SG- building construction - General Assembly
and north parking space - 1/82 - FTWS Inc

Re: Contract HQ 1/82 - General Assembly and
North Parking Garage - Notification of
Change No. 32 (R. P. No. 2) - Amplified
Details of Check Walls of Stair No. 11 -
Dimensional Changes Only on "B"

Re: Contract HQ 1/82 - General Assembly and North Parking Garage -
CHANGE NO. 171 - May 16, 1951 Structural Revisions

2 7 Details of Company #3

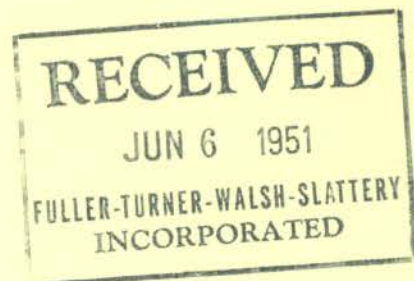
(Approved. As. Notes of Record with 6/8/51 P.B. 124)
46

3 GA-1B-1 21Mar'51 1st Bsmt. - GA Ductwork
(APPROVED AS NOTED 15 June 1951 J.C.B. RESUBMIT)

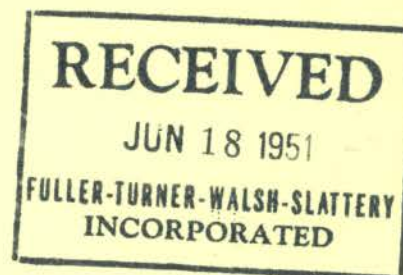
"This drawing is approved, except as noted in yellow crayon."

2 HGP-88-1 14 May '51 Detail of 2"x2"x1/4" angle outriggers to receive
furring on North Wall cols.

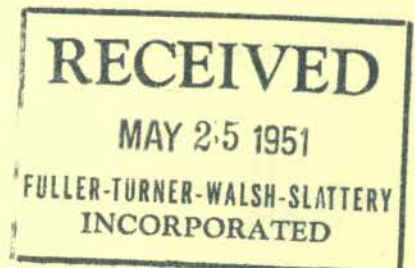
(APPROVED AS NOTED 14 Aug 1951 R.E.N. RESUBMIT)
